**AUTOMATED WEATHER OBSERVATION
SYSTEM (AWOS)**

STATE PROJECT NO. 977-99-0107 - H.008654

ADDENDUM NO. ONE (1)

**AUTOMATED WEATHER OBSERVATION SYSTEM (AWOS)
ST. JOHN THE BAPTIST PARISH AIRPORT
ADDENDUM NO. 1**

E5-A

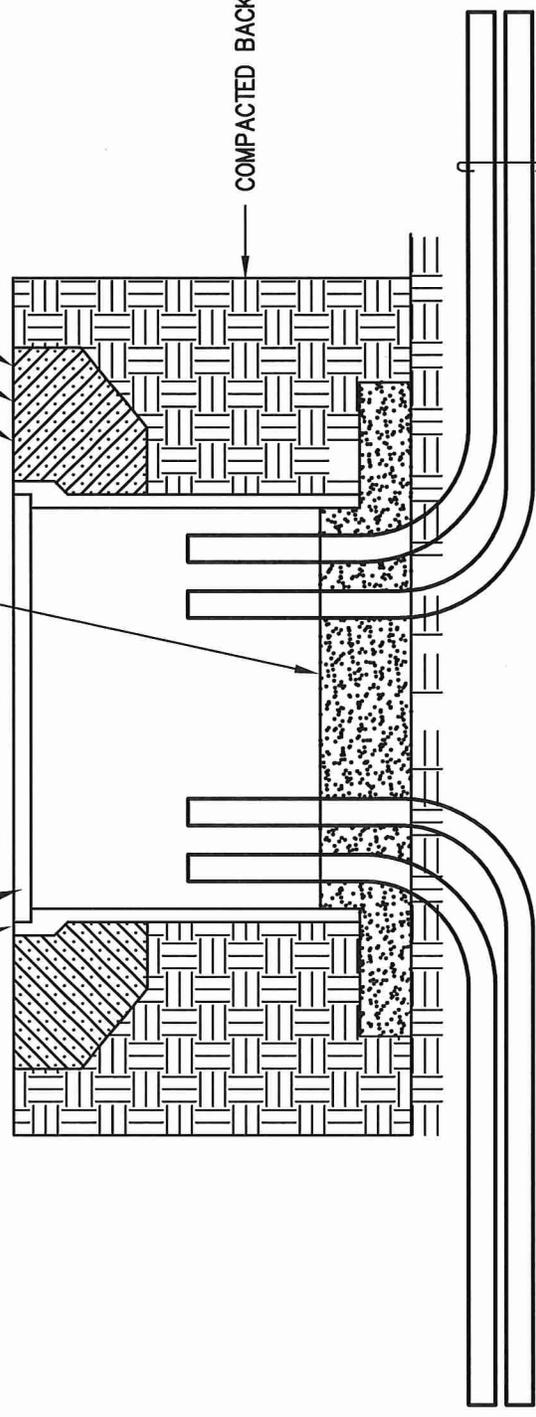
Add the attached “Electrical Junction Box Detail” (E5-A).

8" WIDE X 12" DEEP CONCRETE PERIMETER**
 (CONCRETE @ 4000 PSI, 28 DAYS WITH
 FIBROUS REINFORCEMENT)

JUNCTION BOX SURFACE ELEVATION SHALL BE 1" ABOVE
 EXISTING GRADE. SLOPE CONCRETE PERIMETER AWAY FROM
 JUNCTION BOX LID. ADD COMPACTED EMBACKMENT AS
 NECESSARY FOR PROPER INSTALLATION. SEED SOIL AS
 NECESSARY.
